Private Plan Change Request  
67 (PC67)

**STATEMENT OF EVIDENCE OF HUGH ANTHONY NICHOLSON  
ON BEHALF OF SELWYN DISTRICT COUNCIL**

**URBAN DESIGN AND LANDSCAPE**

**23<sup>th</sup> AUGUST 2021**

Figure 1

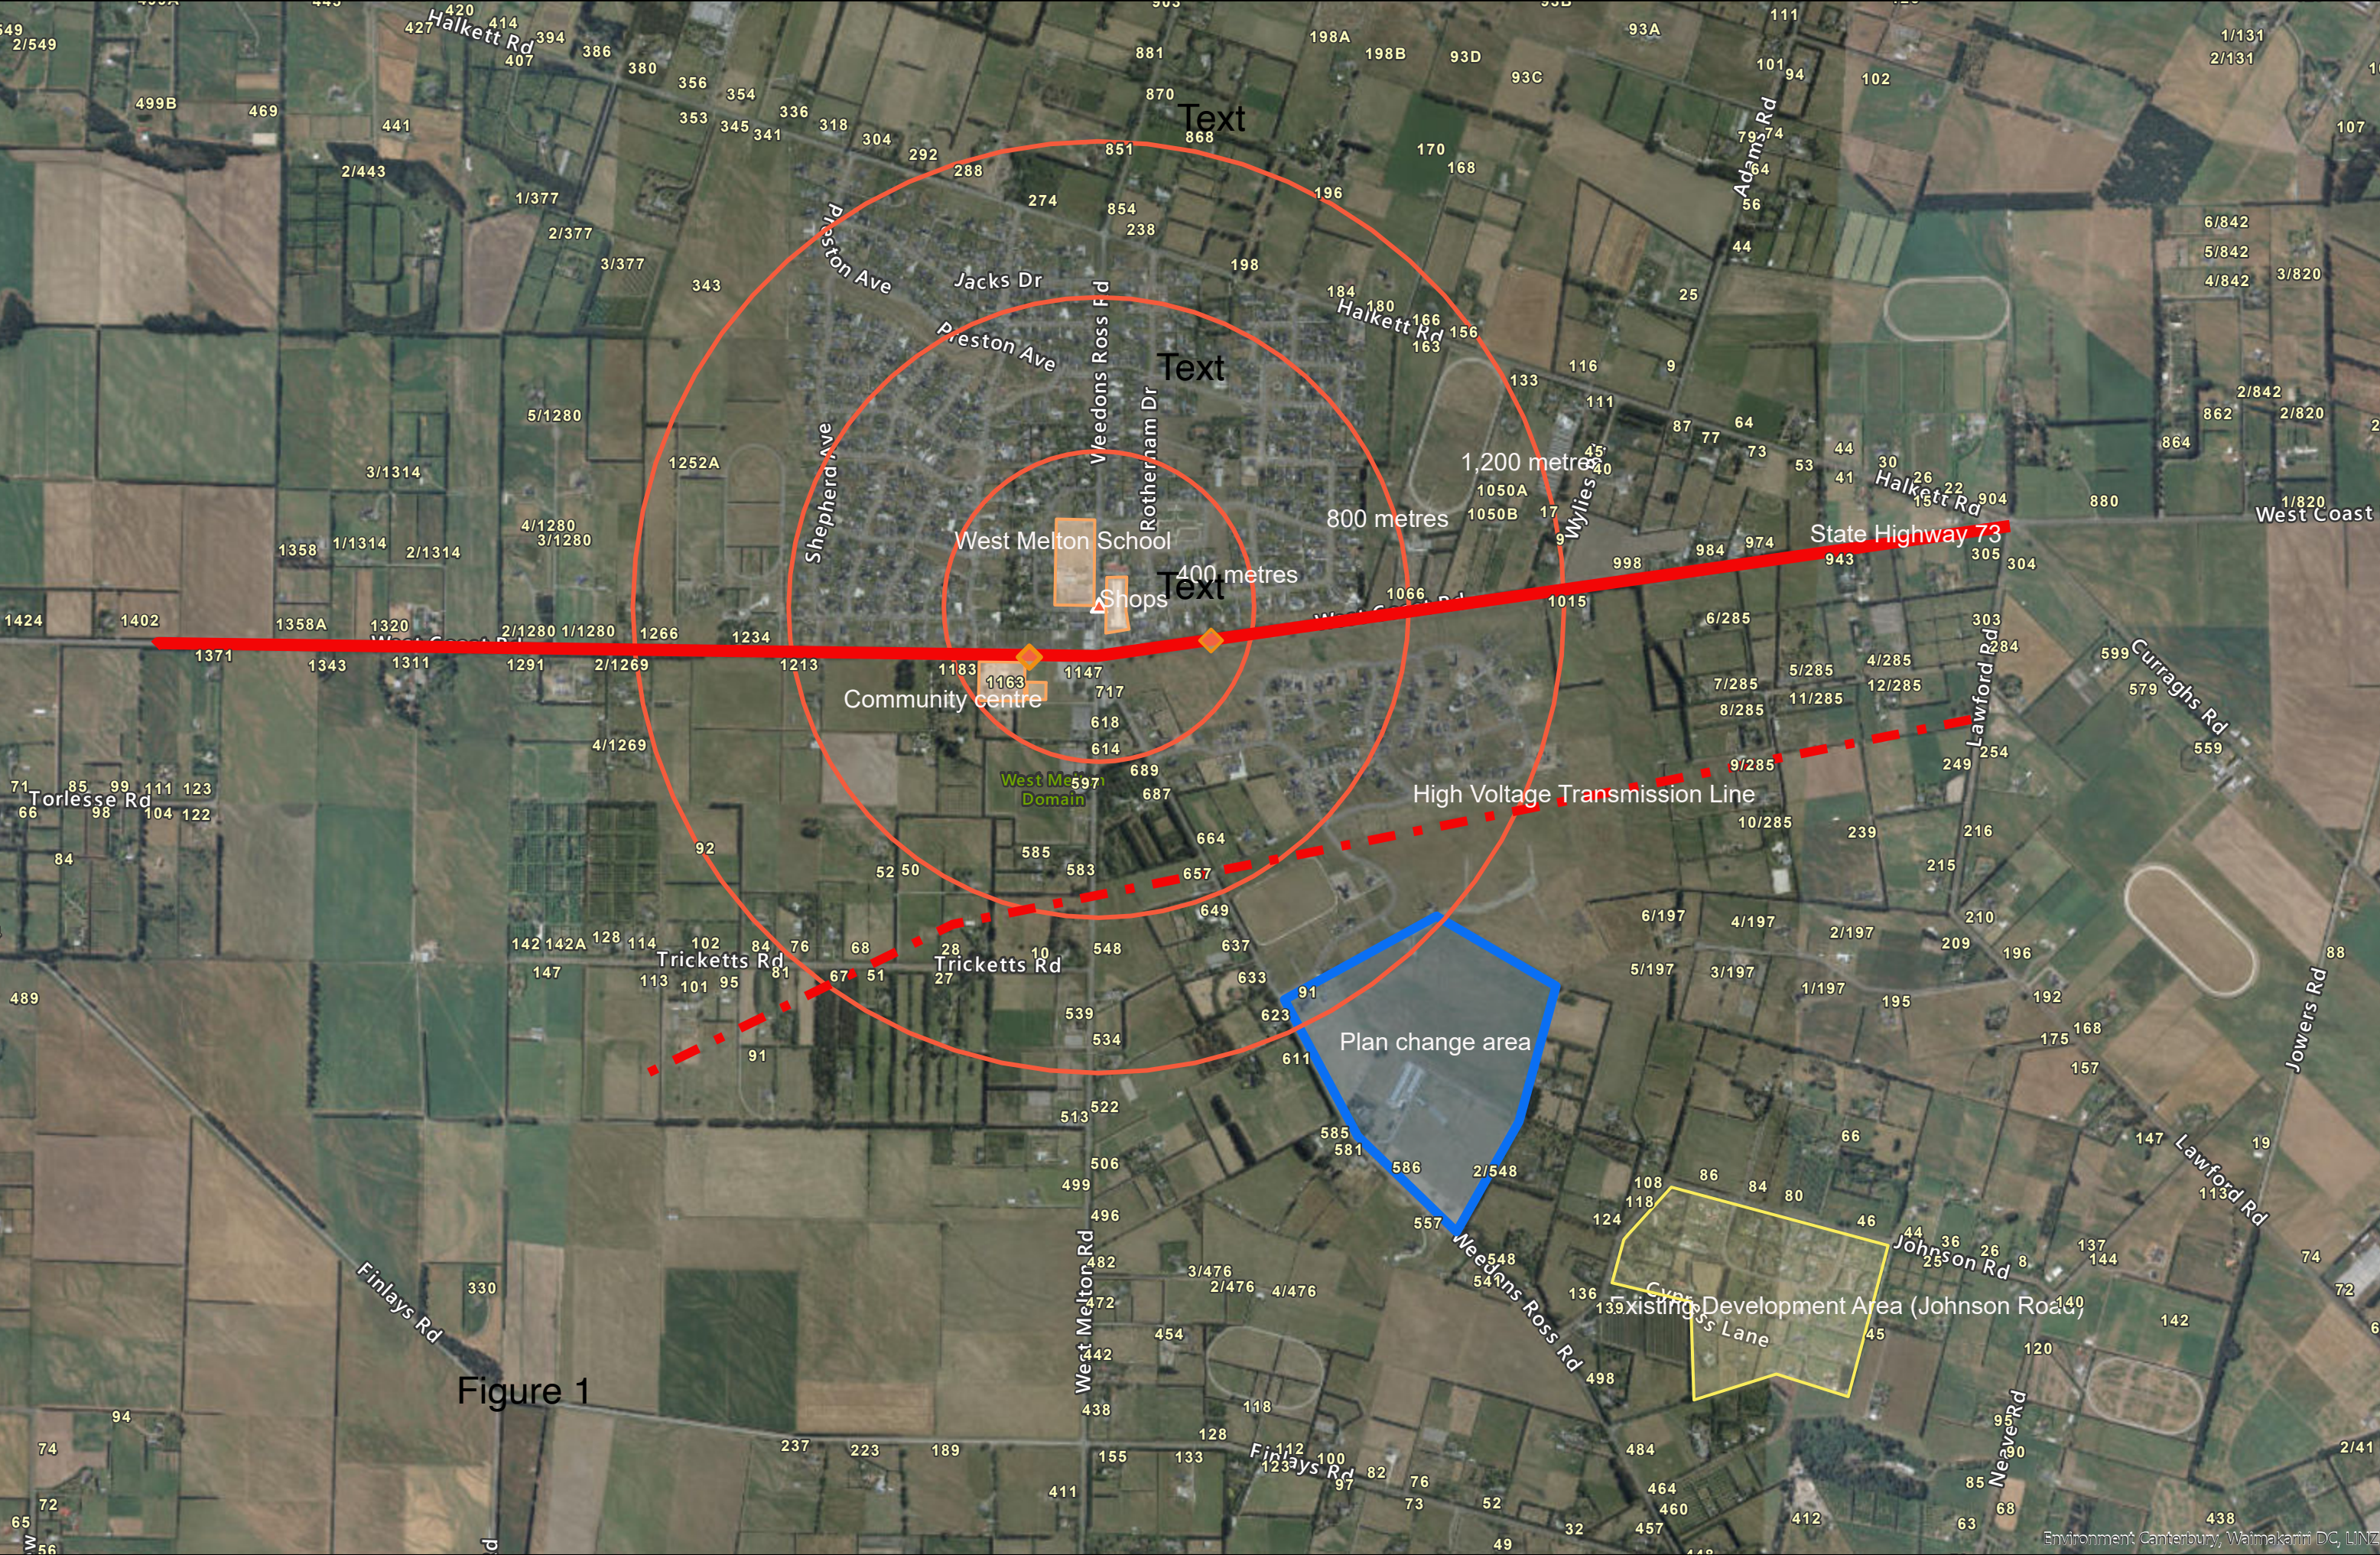
- 6.5 Figure 1 shows 400, 800 and 1,200 metre radius rings around the centre of West Melton to give an indication of walkable catchments, although actual walking distances will be longer depending on the local network of paths.

- 6.7 The existing housing in West Melton is largely located within the two northern quadrants of the walkable catchments shown in Figure 1. The south-western quadrant is undeveloped rural land apart from the community centre and pub, while the south-eastern quadrant includes the lower density Wilfield subdivision south of SH73.

- 6.9 The proposed plan change area is located largely outside the walkable catchments shown in Figure 1 and is separated from the town centre by the high voltage transmission lines and SH73. It extends south-west to within 400 metres of the Existing Development Area (Johnsons Road).

- 6.10 In my opinion the proposed plan change area does not consolidate West Melton or contribute to a compact urban form for the township anticipated in Policies B4.3.98 and B4.3.99 of the SDP. There are significant areas of undeveloped land within all four quadrants of the walkable catchments identified in Figure 1.

- 7.2 There are no facilities for pedestrians or cyclists at the intersection of SH73 and Weedons Ross Road. There are two pedestrian crossing points with pedestrian refuges on SH73 at West Melton, one is located in front of the community centre approximately 180 metres west of the intersection with Weedons Ross Road. The second one is sited approximately 295 metres east of the intersection (these are shown by orange diamonds in Figure 1).
